**TOWN OF OCEAN RIDGE
PLANNING & ZONING REGULAR MEETING
AGENDA**

**May 19, 2026 at 9:00 AM
Town Hall - Meeting Chambers**

To:	Planning & Zoning Board Members
From:	Corey O’Gorman, Town Planner
Meeting Date:	May 19, 2026
Subject:	7 Harbour Dr N – Development Plan Review

**PLAN REVIEW REPORT
5920 N Ocean Boulevard
05/06/2026**

Sheet: east and west elevations

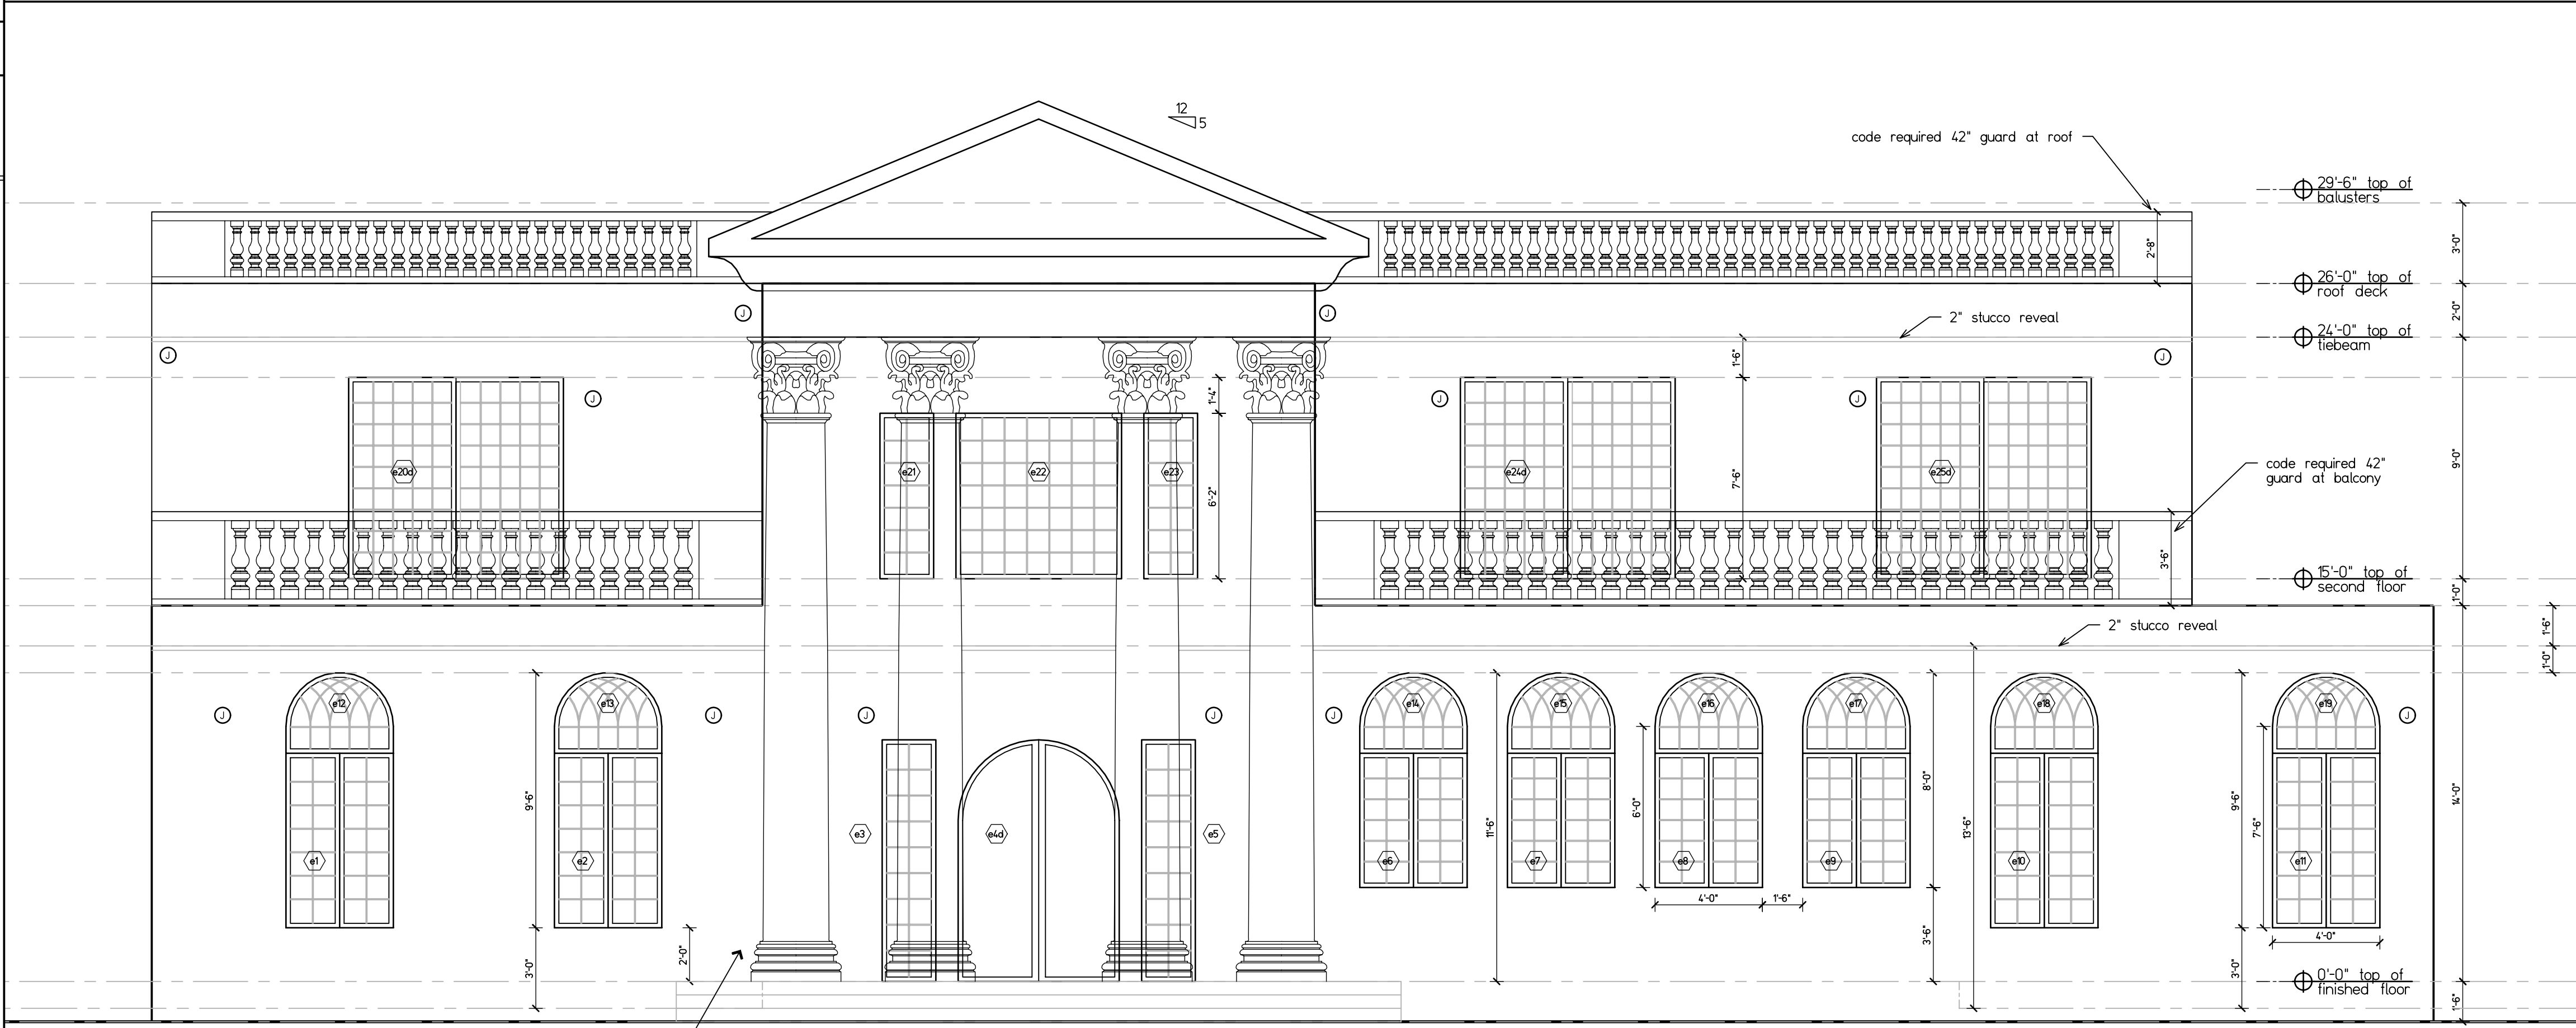
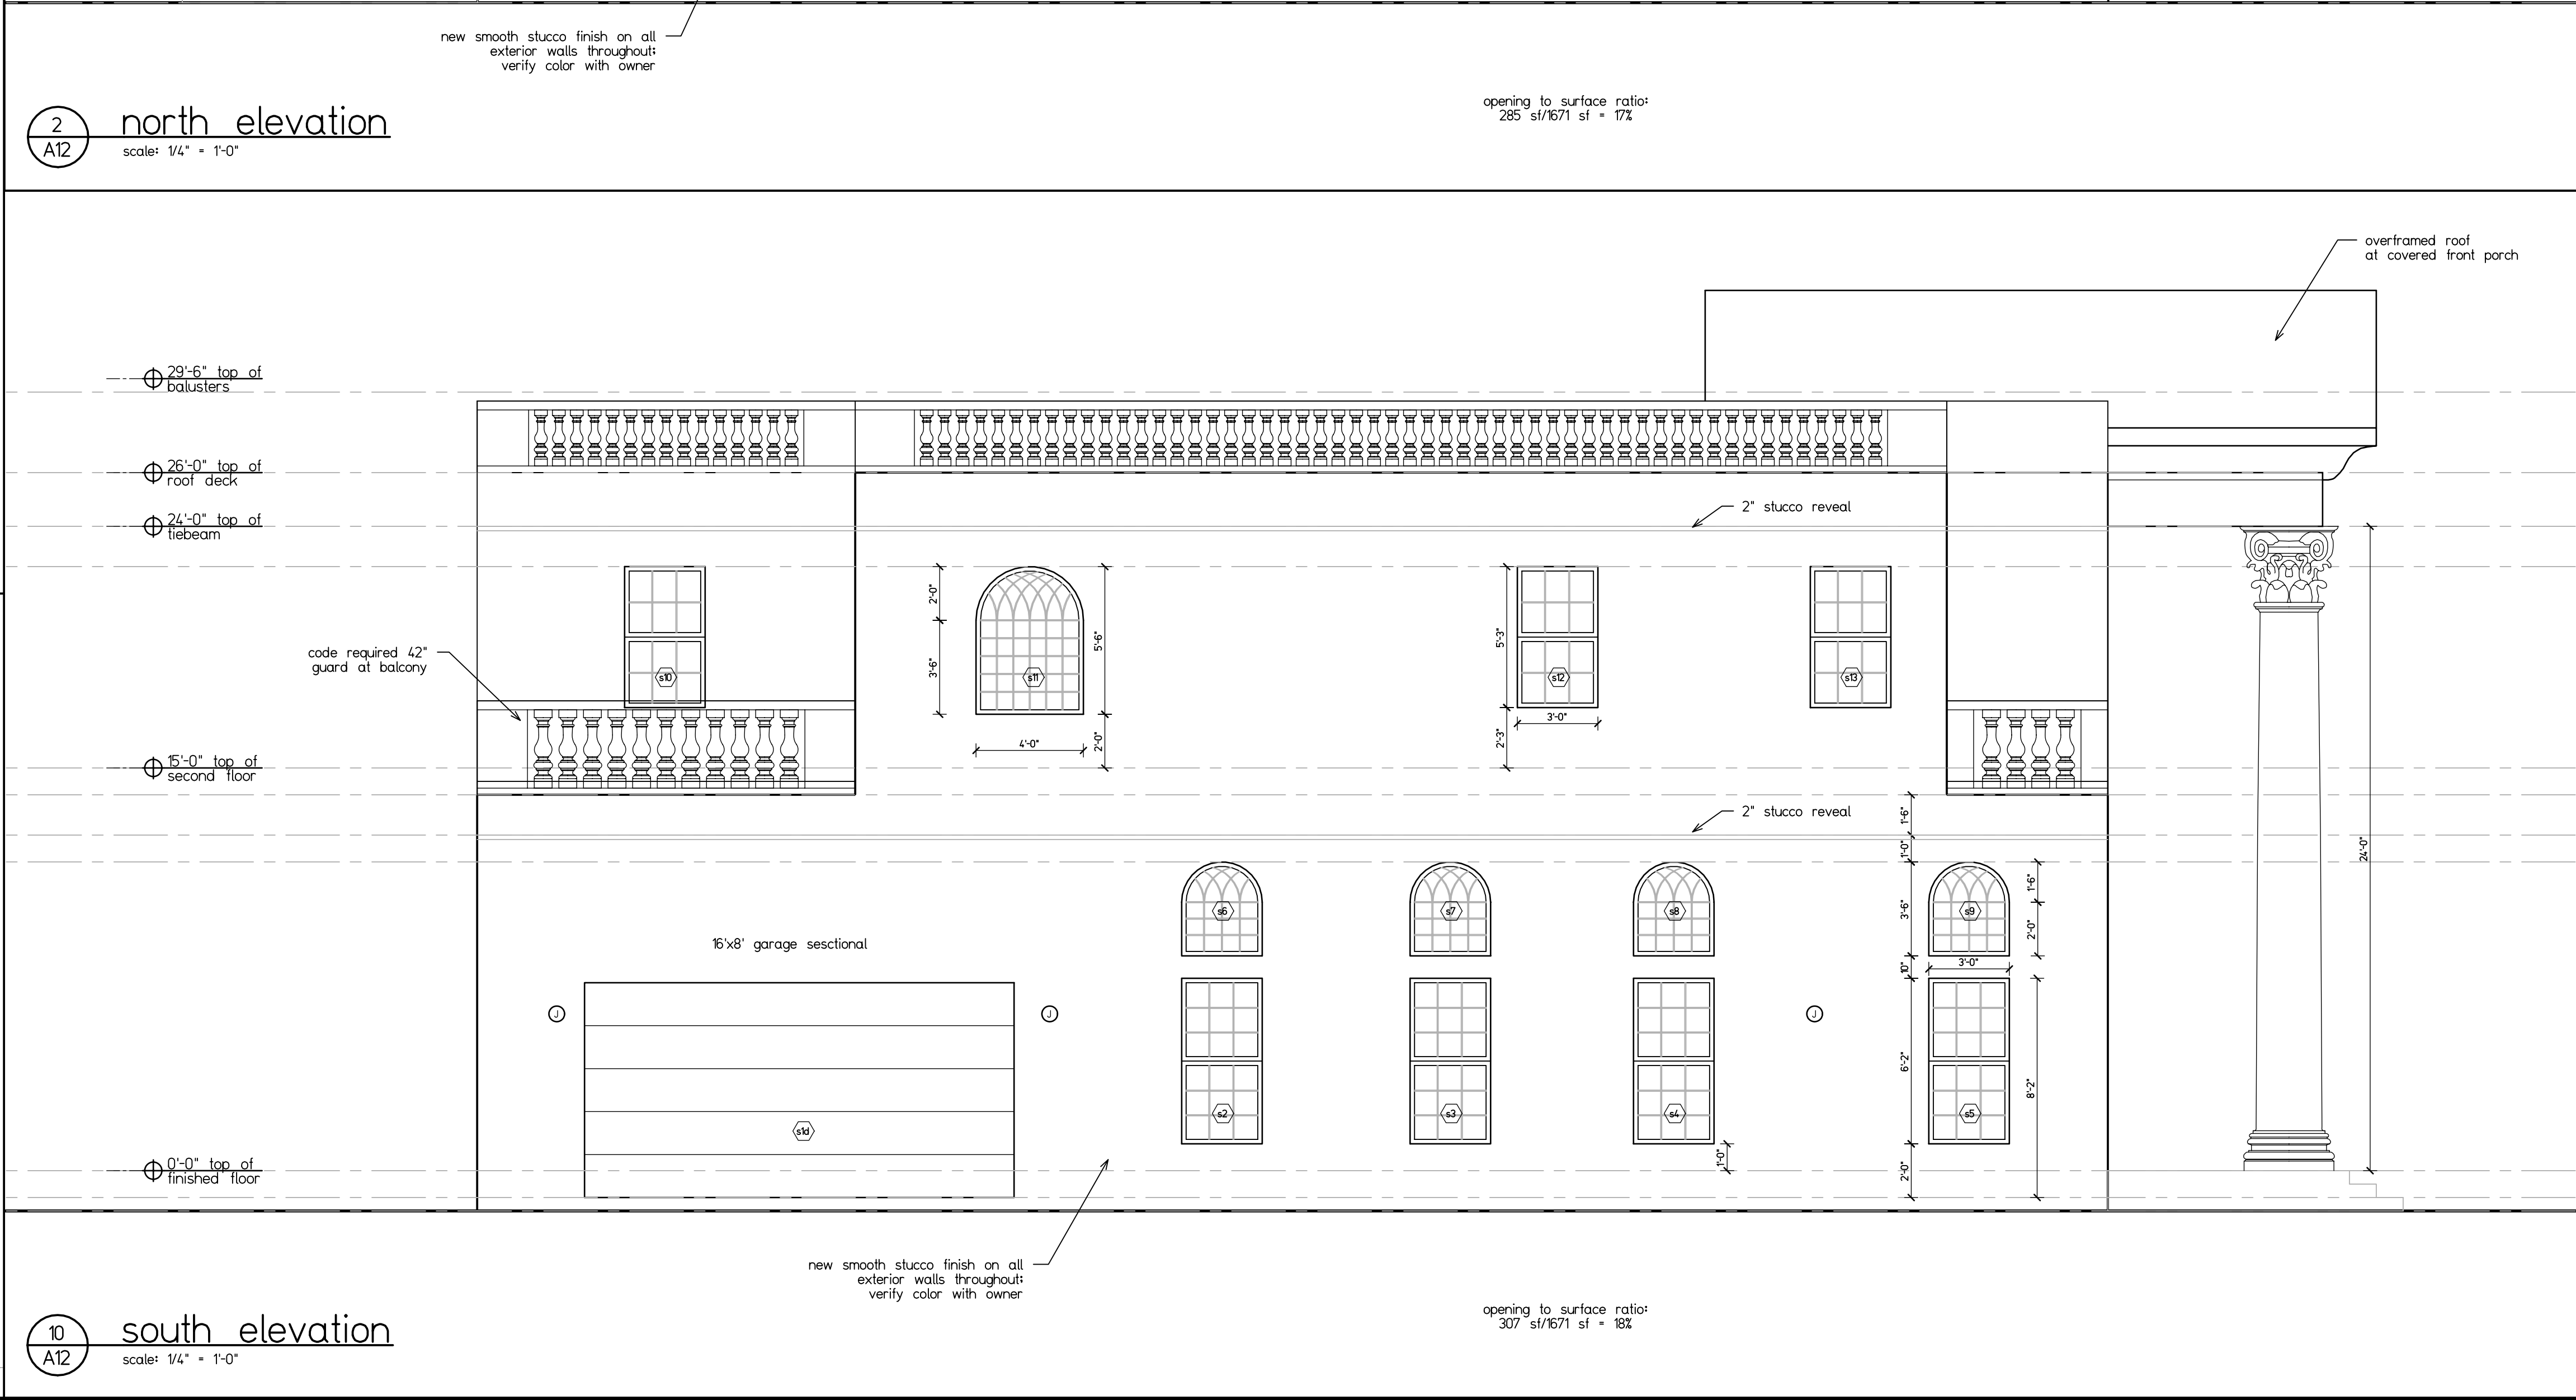
Comment: Please revise elevation sheets A11 and A12 to provide the calculations necessary to ensure compliance with the 15% requirement.

Comment: Please revise sheets A11 and A12, and other sheets as applicable to comply with the maximum height requirements in this code section.
